RTB CorrectionReissue date: **15- Jun -97**

Model: AD-1		Date: 19-Mar-97	No: 26A
Subject: Paper jam		Prepared by: M.Horiike	
From: QAC 2nd Field Information Dept.			
Classification:	<input type="checkbox"/> Troubleshooting	<input checked="" type="checkbox"/> Part information	<input type="checkbox"/> Action required
	<input type="checkbox"/> Mechanical	<input type="checkbox"/> Electrical	<input type="checkbox"/> Service manual revision
	<input type="checkbox"/> Paper path	<input type="checkbox"/> Transmit/receive	<input type="checkbox"/> Retrofit information
	<input type="checkbox"/> Other ()

Model: AD1-Paper Tray Unit (PS330)		Date: 23-Jul-97	No: 36
Subject: Noise		Prepared by: K.Ugaeri	
From: QAC 2nd Field Information Dept.			
Classification:	<input type="checkbox"/> Troubleshooting	<input type="checkbox"/> Part information	<input checked="" type="checkbox"/> Action required
	<input type="checkbox"/> Mechanical	<input type="checkbox"/> Electrical	<input type="checkbox"/> Service manual revision
	<input type="checkbox"/> Paper path	<input type="checkbox"/> Transmit/receive	<input type="checkbox"/> Retrofit information
	<input type="checkbox"/> Other ()

Model: PS330 (Paper Tray f

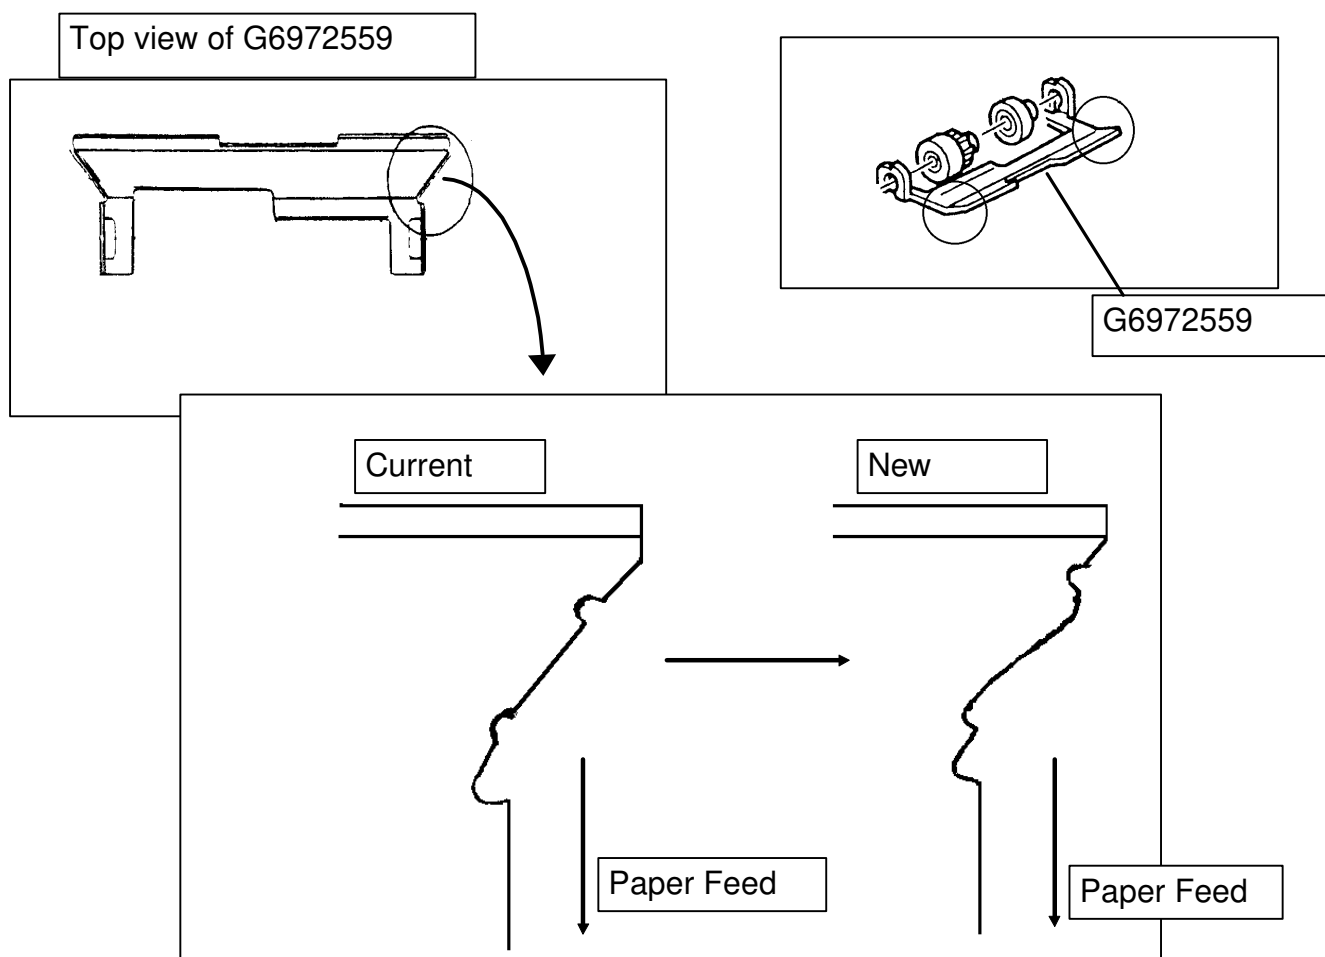
Paper jam from the ***paper tray unit (PS 330)***.

The paper contacted the uneven edge of the upper guide paper feed.

The shape of the upper guide - paper feed has been changed from January Production '97.

2. Paper Feed Section (G697)

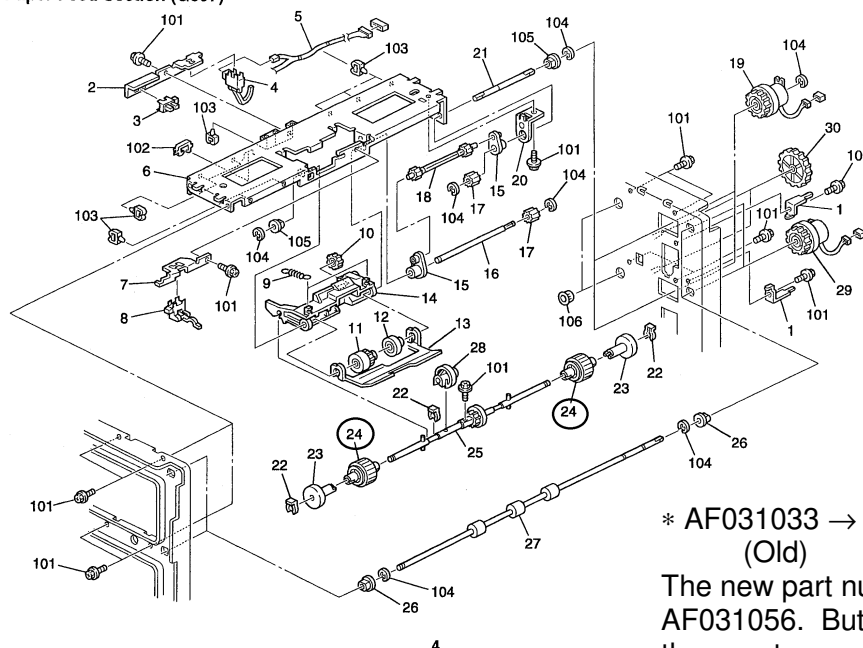
SYMPTOM: Paper jam

CAUSE: Paper skewing or no feed from PS330 (Paper Tray)

Countermeasure: The diameter of the paper feed roller has been modified from 30φ to 32φ to improve paper feed.

* AF031033 → AF031056
(Old) (New)

The new part number of the feed roller is AF031056. But do not order this part until the countermeasure kit is out of stock.
